G13-12

Proposed Change as Submitted

Public Hearing Results

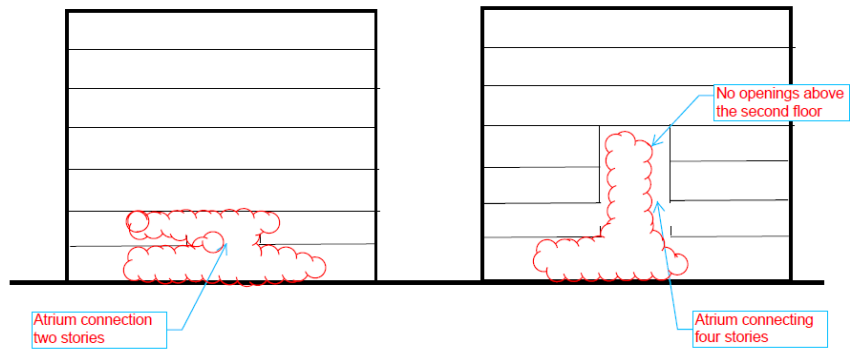
With the recognition that natural light creates a healthier environment, the use of light wells is becoming increasingly common in building. We are seeing light wells extending through an entire 6-8 story building, and many of these light wells are provided with the sole intent to provide light. The walls of these light wells have no openings into the adjacent floors onto which they provide light (i.e., solid walls with nonoperable windows or doors) and there are no walking surfaces above the lowest levels.

But because these light wells are “connecting” more than 2 stories, smoke control systems are being required. But what benefit is the smoke control providing?

We ask you to consider this, if there are no operable openings in the walls of the atrium above the 2nd story, and there are no walking surfaces within the atria above the 2nd story, are the occupants on the 1st and 2nd story in more danger than if there were no light well, a.k.a., no atrium.

2010 Guideline

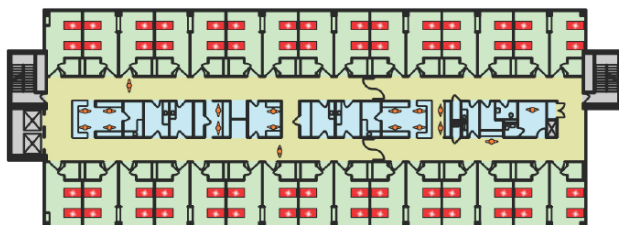
The sketch above demonstrates the impact of occupants on the increased space needed to treat the same number of patients as well as house the same number of staff. Increased requirements for support spaces, such as computer server closets, soiled utility, increased storage per room and staff support spaces has caused the support "core" to increase. This in addition to patient rooms that are allowed to only have one bed, rather than the past allowance for two beds per patient room.

Figure 425.1 EPA Map of Radon Zones

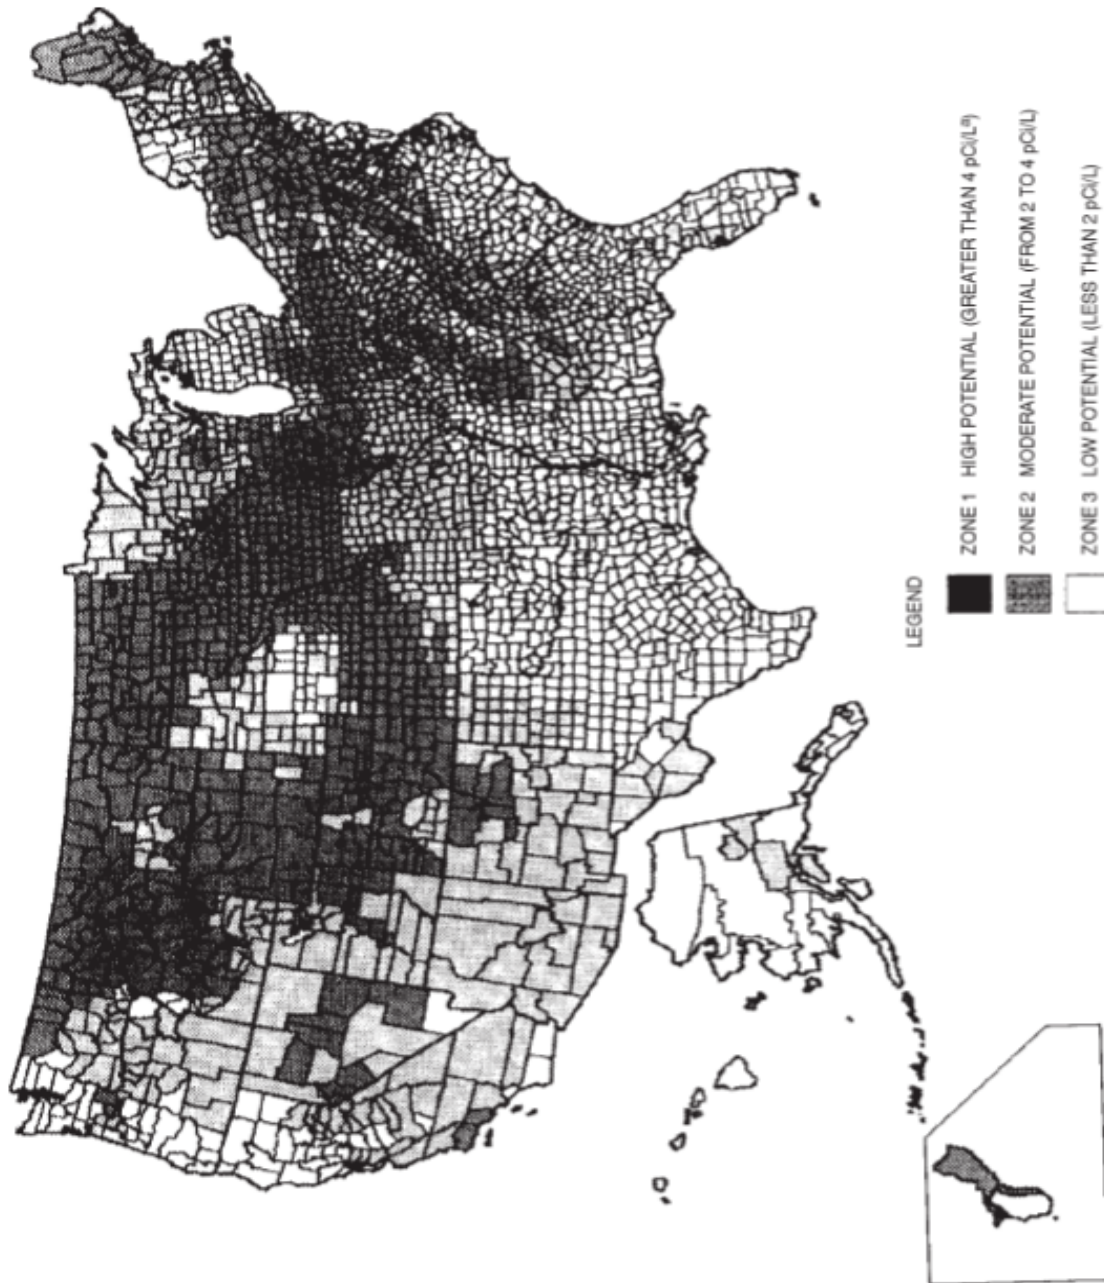
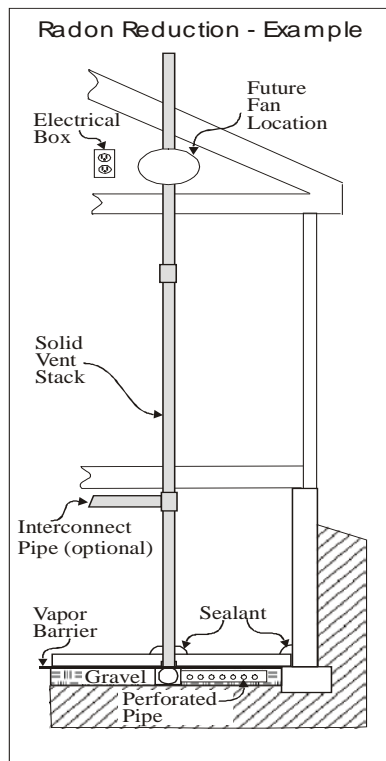
The United States Environmental Protection Agency and the United States Geological Survey have evaluated the radon potential in the United States and developed this map of radon zones. The map assigns each of the 3,141 counties in the United States to one of three zones based on radon potential. Zone 1 areas have a predicted average indoor radon screening level greater than 4 pCi/L (picocuries per liter). Table 425.1 lists the Zone 1 counties illustrated on the map.

Figure 425.1 EPA Map of Radon Zones

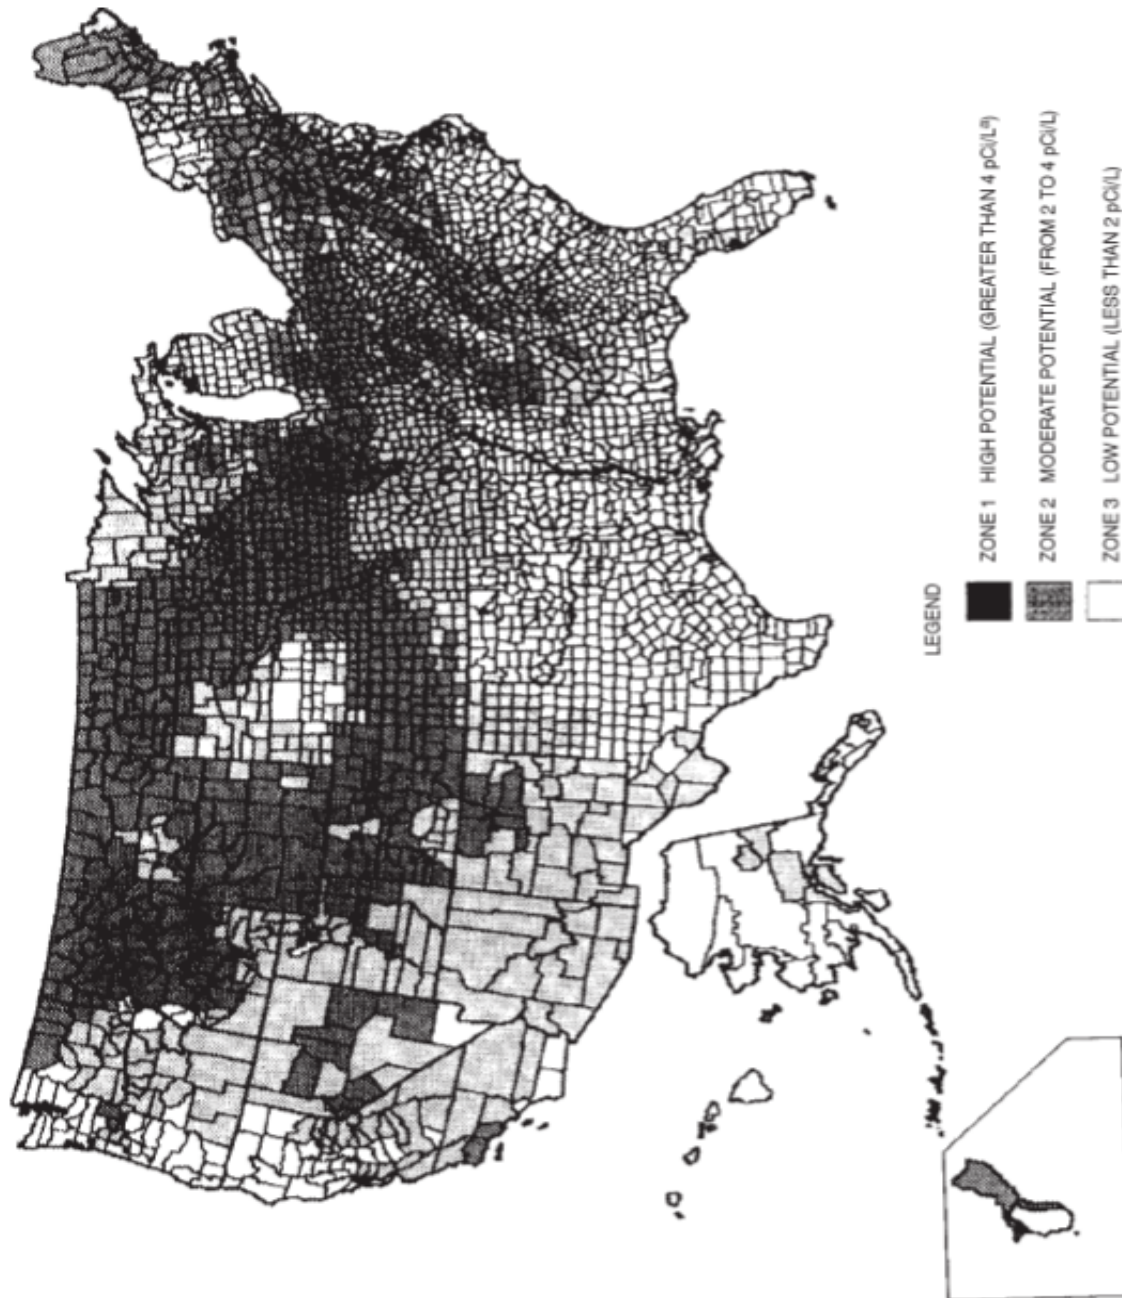
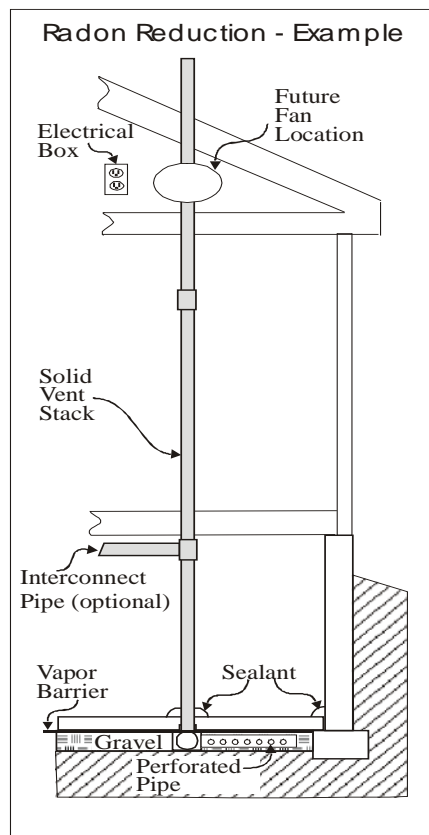
The United States Environmental Protection Agency and the United States Geological Survey have evaluated the radon potential in the United States and developed this map of radon zones. The map assigns each of the 3,141 counties in the United States to one of three zones based on radon potential. Zone 1 areas have a predicted average indoor radon screening level greater than 4 pCi/L (picocuries per liter). Table 425.1 lists the Zone 1 counties illustrated on the map.

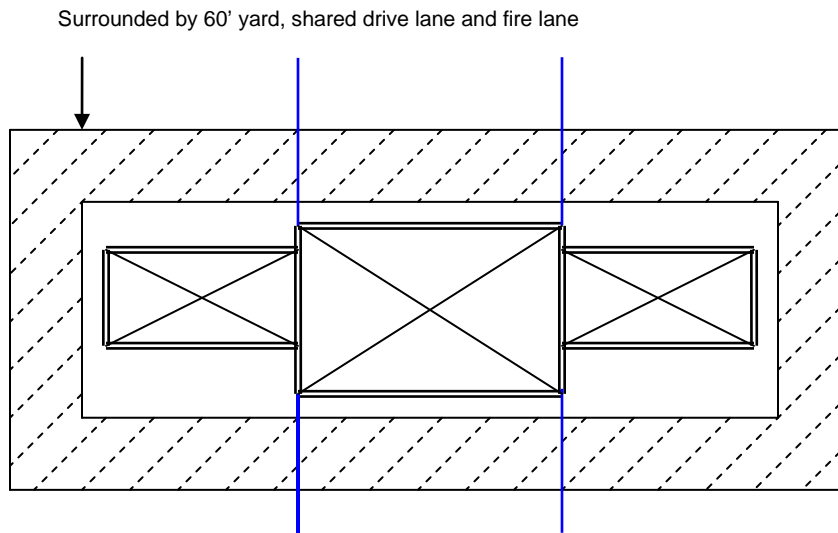
Example 1: A former strip center with the middle anchor retail divided only by lease lines. As a collection of buildings, surrounded by a 60' yard, each separate owner was permitted unlimited area. The surrounding yard was usually a shared drive lane and fire lane.

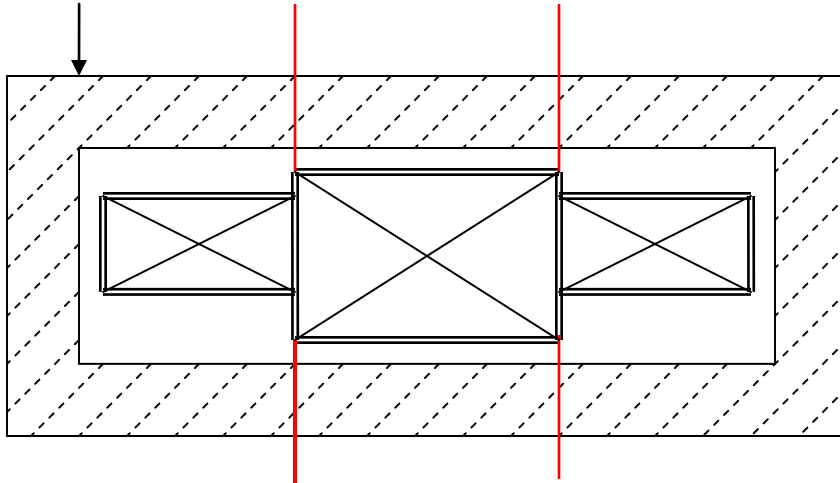
Example 2: The same collection of buildings, but now divided by a lot line between individual properties. As such, they are no longer permitted unlimited area.

Surrounded by the same 60' yard, shared drive and fire lane

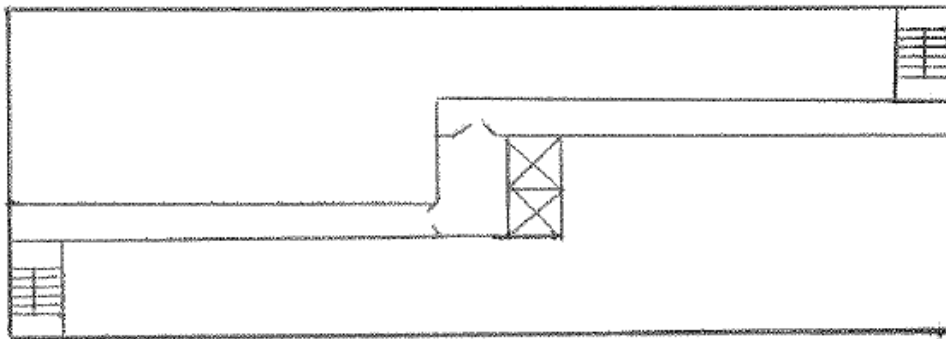
1. Corridor passes through passenger elevator lobby. If provided with access to a stair and proper construction, could this be a Fire Service Access Elevator Lobby and/or an Occupant Evacuation Elevator Lobby?

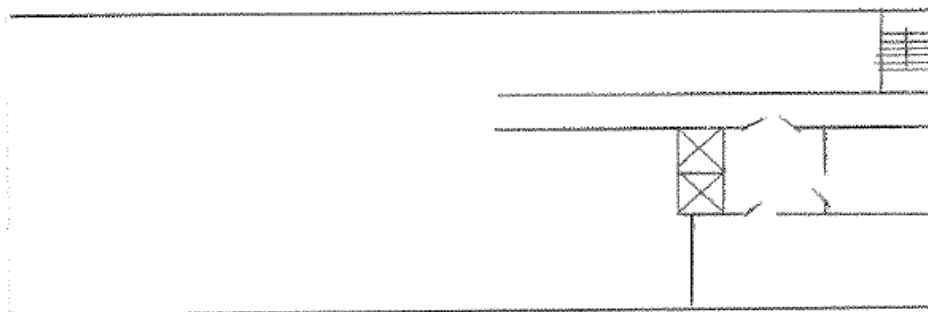
2. Rooms connect to and exit through elevator lobby. If provided with access to a stair and correct construction, could this be a Fire Service Access Elevator Lobby and/or an Occupant Evacuation Elevator Lobby?

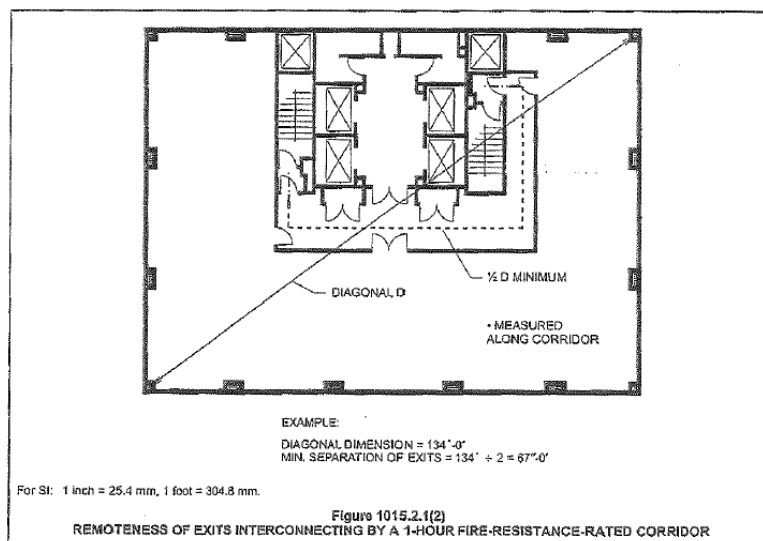
Even the commentary has an example of what appear to be restrooms off an elevator lobby as follows:

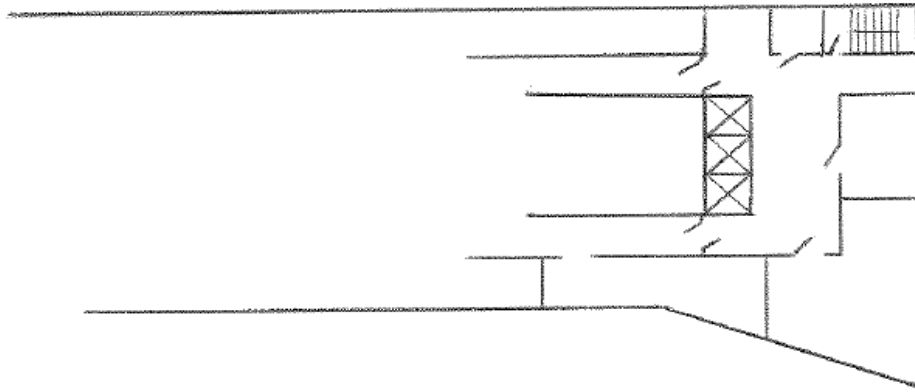
3. The following is an example of corridors passing through a lobby, along with rooms with direct connection to lobby, serving as passenger elevator lobby Fire Service Access lobby and/or Occupant Evacuation Elevator lobby. This is an actual design submitted for review.
